Access Compliance Report Public Rights-of-Way (Curb Ramps)

Intersection ID: 27963 Main Street: FAIR_ISLE_DR Cross Street: MCGINN'S_TRACE_CT Location: NW

ADA ID: 2D0B0EC153DC Ramp Type: PerpDiag Initial Pass/Fail: Fail Overall Compliance: No Severity Score: 50

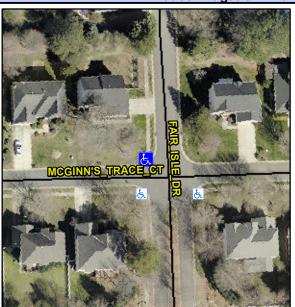
Not Found, R304.2.2, R304.5.3

Field Measurements/Component Compliance					
Compliance Description		Data	Comp	liance Description	Data
N/A	Ramp Length (in)	94.0	No	Ramp Slope (%)	12.2
Yes	Ramp Width (in)	48.0	No	Ramp XSlope (%)	8.8
N/A	Flare Type LT	N/A	N/A	Flare Type RT	N/A
N/A	Flare Slope LT (%)	N/A	N/A	Flare Slope RT (%)	N/A
N/A	Flare Traversable LT?	N/A	N/A	Flare Traversable RT?	N/A
N/A	Landing Length (in)	N/A	N/A	DWS Provided?	N/A
N/A	Landing Width (in)	N/A	N/A	DWS Contrast?	N/A
N/A	Landing Slope (%)	N/A	N/A	DWS Length (in)	N/A
N/A	Landing X Slope (%)	N/A	N/A	DWS Full Width?	N/A
N/A	Landing Curb? (Y/N)	N/A	N/A	DWS Offset (in)	N/A
N/A	Shared Landing?	N/A			
N/A	Gutter Ponding?	N/A	N/A	Gutter Slope (%)	N/A
N/A	Gutter Lip Ht (in)	N/A	N/A	Gutter X Slope (%)	N/A
N/A	Painted X Walk1?	No	N/A	Painted X Walk2?	No
	X Walk 1 Direction	To S		X Walk 2 Direction	To E
N/A	X Walk 1 Width (in)	N/A	N/A	X Walk 2 Width (in)	N/A
	X Walk 1 Slope (%)	5.3		X Walk 2 Slope (%)	1.4

Remove & Replace Curb Ramp With Two New Directional Ramps or Equivalent.
